Development Services Staff Report

File Number	PL2020-134
File Name	PRELIMINARY DEVELOPMENT PLAN – Lee's Summit R-7 Middle School #4
Applicant	DLR Group
Property Address	1001 SE Bailey Rd
Planning Commission Date	July 9, 2020
Heard by	Planning Commission
Analyst	Hector Soto, Jr., AICP, Planning Manager
Checked By	Kent D. Monter, PE, Development Engineering Manager

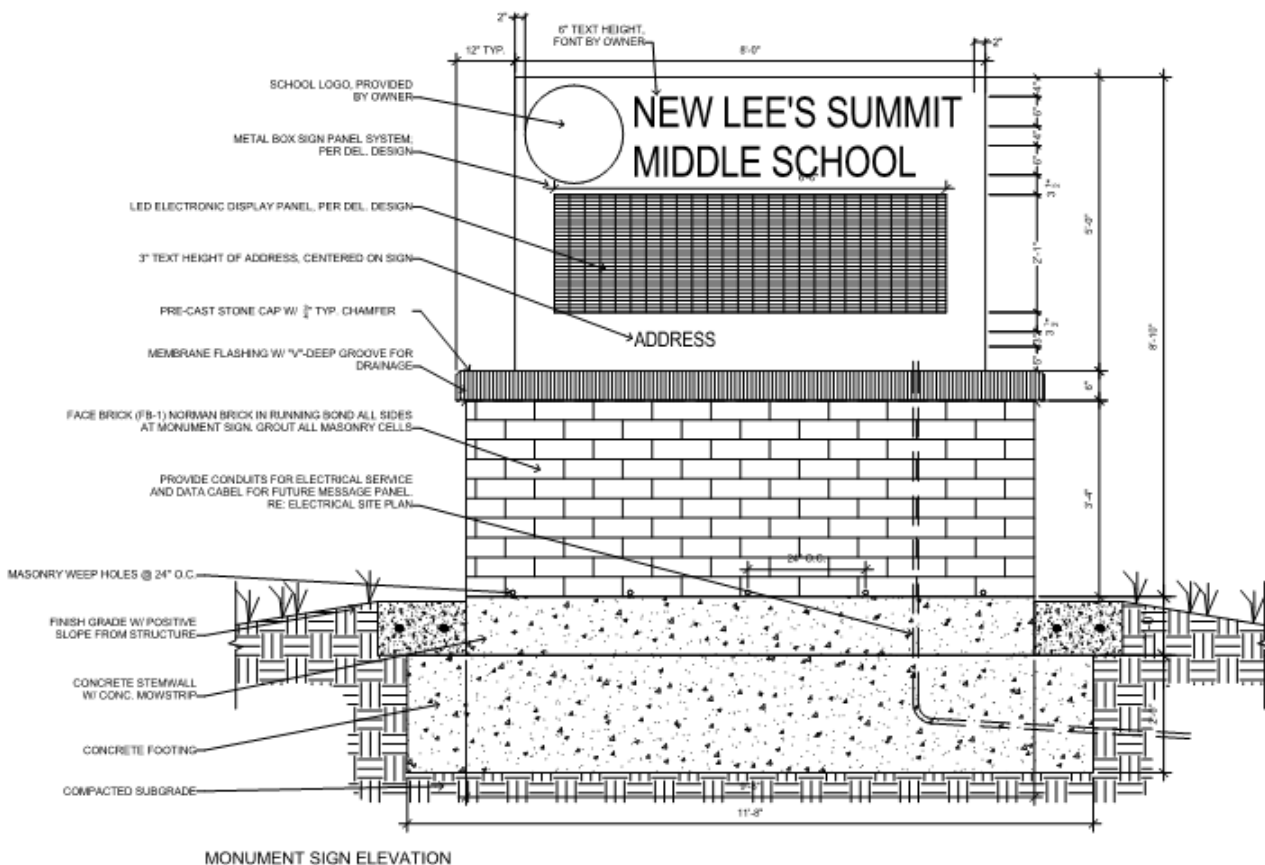
The development incorporates adequate ingress and egress and an internal road network to mitigate traffic congestion. Two driveways provide primary access to the site along SE Bailey Rd. Direct connection to the abutting Newberry subdivision to the west is provided as part of this project via existing street stubs for SE 13th St and SE Cape Dr. A third connection for pedestrian-only access between the school and the Newberry subdivision is proposed via a sidewalk extension along the existing SE 15th St street stub; vehicular access will not be allowed at this location. The actual street stub will be removed and right-of-way vacated. A utility and access easement will be retained to accommodate the pedestrian connection.

Tree Size. Modification requested.

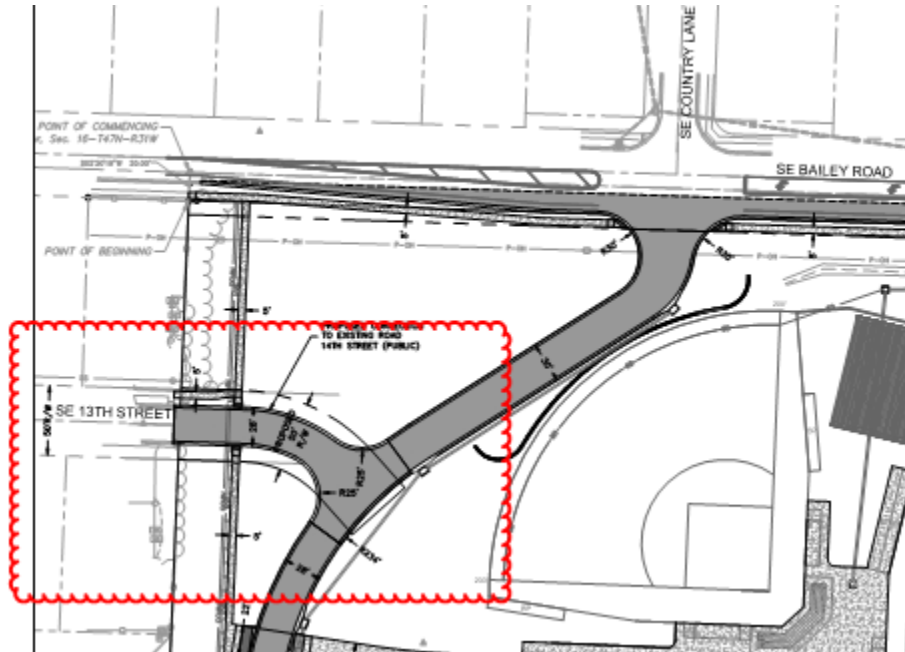
- Required – Deciduous trees shall be a minimum 3" caliper in size at the time of planting.
- Proposed – 2" caliper deciduous ornamental trees
- Recommended – The UDO's minimum 3" caliper size requirement applies to deciduous trees as a whole. The minimum size requirement applies equally to shade trees as it does to ornamental trees. Based on feedback the City has received from the development community, typical landscape nursery stock of ornamental trees is 2" caliper in size. The City has also received feedback from landscape professionals that the survivability of 2" caliper ornamental trees is significantly greater than that of larger ornamental trees. Given this information, Staff supports the request to allow 2" caliper deciduous ornamental trees.

1. A modification shall be granted to the minimum 3" deciduous tree caliper size, to allow 2" caliper ornamental trees.
2. Two monument signs with an overall height of 8'-10", a sign face area of 40 sq. ft. and a sign structure area of 77 sq. ft. shall be allowed along SE Bailey Rd as depicted on the preliminary development plan.

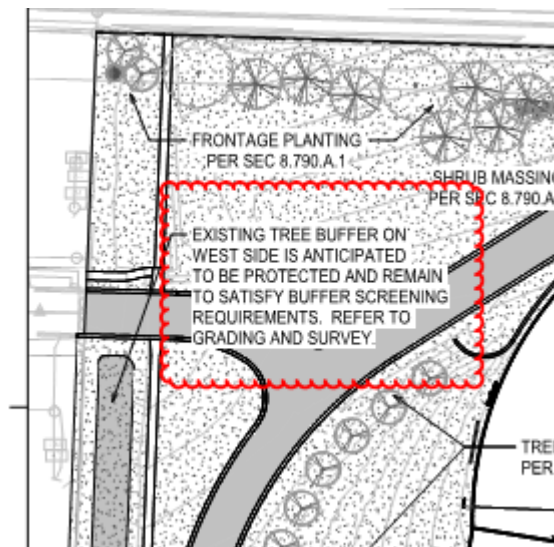
- **Can the existing treeline along the west project boundary adjacent to the Newberry subdivision be retained?**

Current plans call for the protection and retention of the existing treeline to serve as a buffer between the abutting developments.
